SUBJECT: Trip Report for Visit to Browns Ferry Nuclear Power Stations 14 - 16 May 95

SUBJECT: NRC CONTRACTOR - DALE NEBUDA VISIT - VEHICLE BARRIER SYSTEM (VBS) FOR BFN

Subject: VEHICLE BARRIERS & NUREG/CR 6190

SKETCH 1

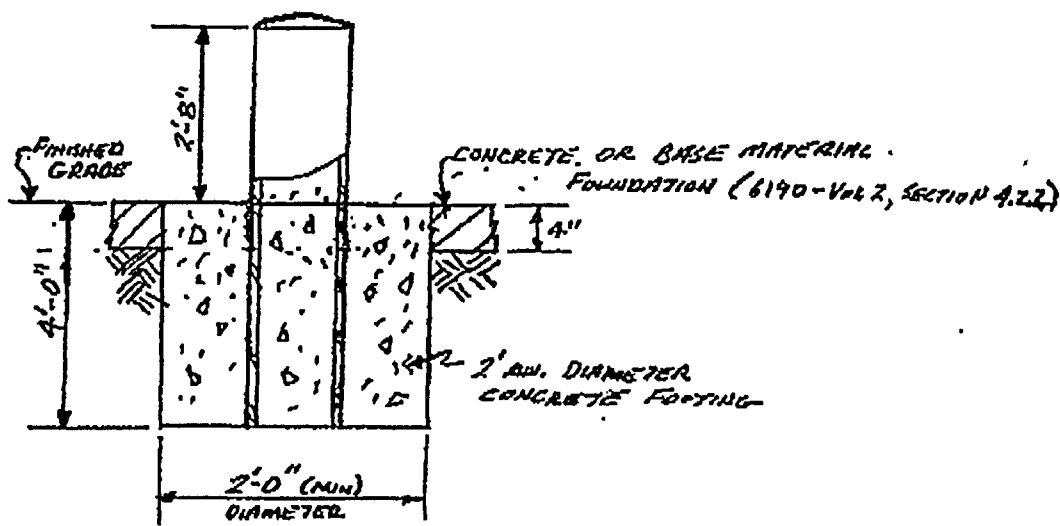
- Q1) CAN YOU CLARIFY THE TERM FOUNDATION AS USED IN NUREG/CR 6190, VOL 2 TABLE 4.3 AND IN SECTION 4.2.2 OF THE SAME DOCUMENT? THIS QUESTION IS BASICALLY RELATED TO BOLLARD TYPE BARRIERS. TWO SKETCHES ARE ATTACHED WHICH REPRESENT TWO INTERPRETATIONS. PLEASE COMMENT ON WHICH SKETCH CONFIGURATION IS CORRECT INTERPRETATION TO DETERMINE BOLLARD RATING FROM TABLE 4.3. ARE BOTH ACCEPTABLE?

6. Also discussed was a list of questions faxed to me on 3 May (see enclosure 2). My response to these questions is as follows.
  - a. Question a1. Sketch 2 is correct.
